## TELEPHONE SETS—831- AND 2831-TYPE

### IDENTIFICATION, INSTALLATION, CONNECTIONS, AND MAINTENANCE

1.001 This addendum supplements Section 503-702-101, Issue 6.

Fig. 9—831- and 2831-Type Telephone Set, Connections (Sheet 3 of 6)

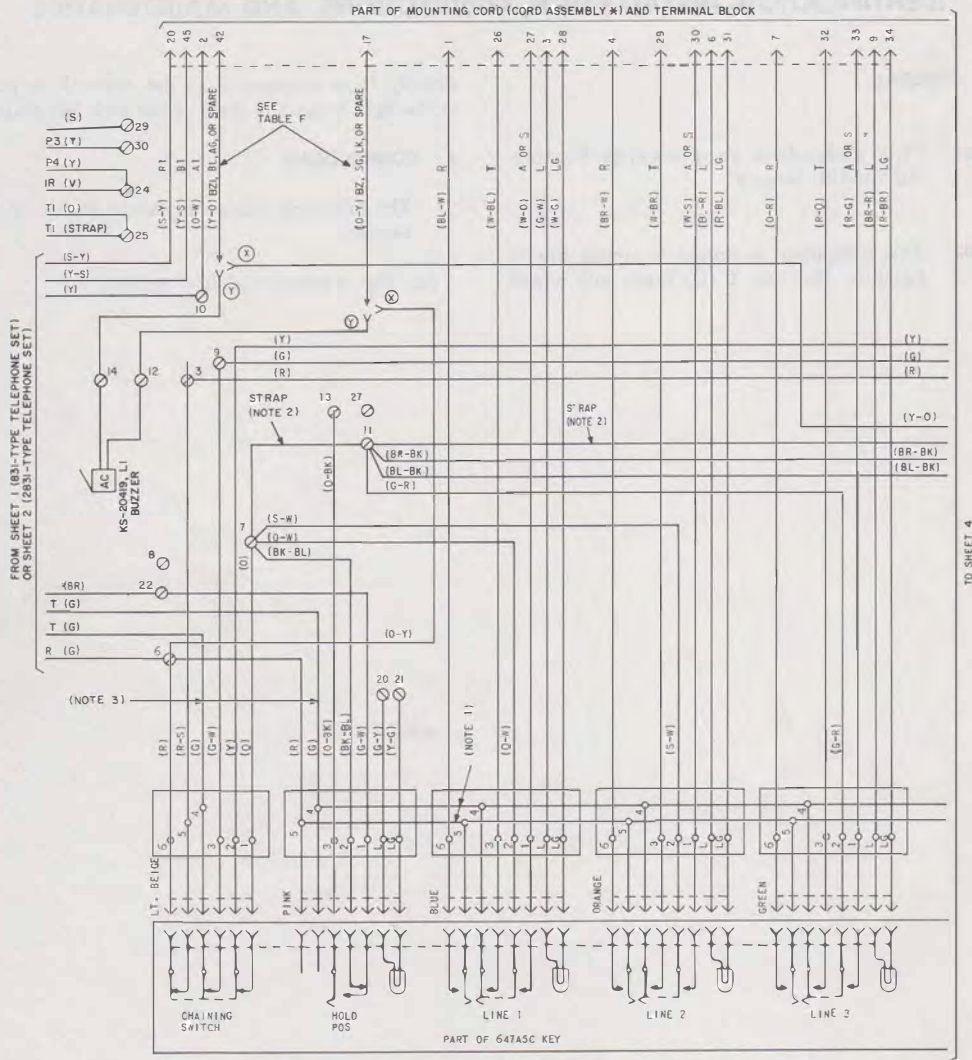
1.002 This addendum is issued to revise Fig. 9 to show the two T (G) leads are wired

directly from terminal F of the network to pin 4 of the light beige and pin 4 of the pink 508 plugs.

(a) Fig. 9 (sheet 3 of 6) — revised
